## Bridge of the Month 138, June 2022 Melkington

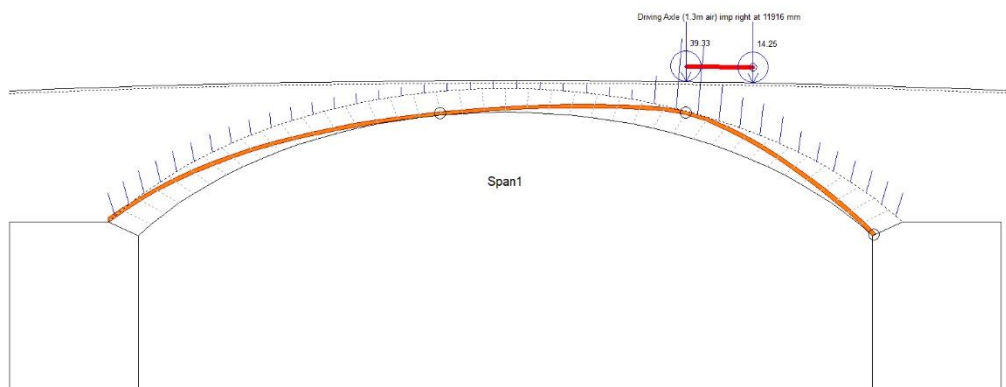
One thing I was looking for was mortar loss. The assessment that NH relied on to condemn the bridge said up to 100mm and reduced the whole ring by the full 100mm. I have examined the soffit closely and found negligible mortar loss. In the image below are 3 badly weathered bricks, one top left, one top centre and one bottom right. These were the only such bricks found. They are isolated, and certainly don't justify discounting a full ring.

Also in the analysis, there was no consideration of backing. Were this bridge being considered within a network owned by a regional council, it would be quite unacceptable to take the most conservative assumption at every point. What the bridge owners need is a reasonable assessment

which allows them to prioritise work. If a bridge in this condition were slated for immediate repair, what other structures would be pushed down the list?

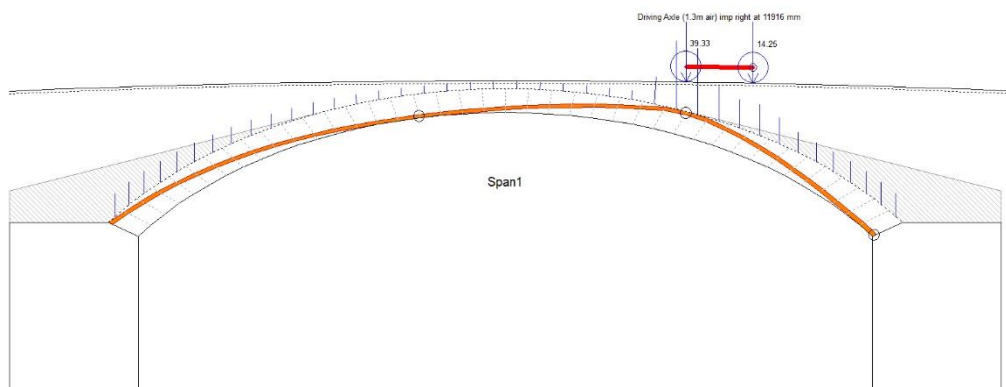
Putting those dimensions into Archie-M and auto-running loads from BD21 (because the assessment was done before CS454 was published) the worst case is a two-axle bogie with impact.

Adding a modest amount of backing makes the bridge more than adequately safe.
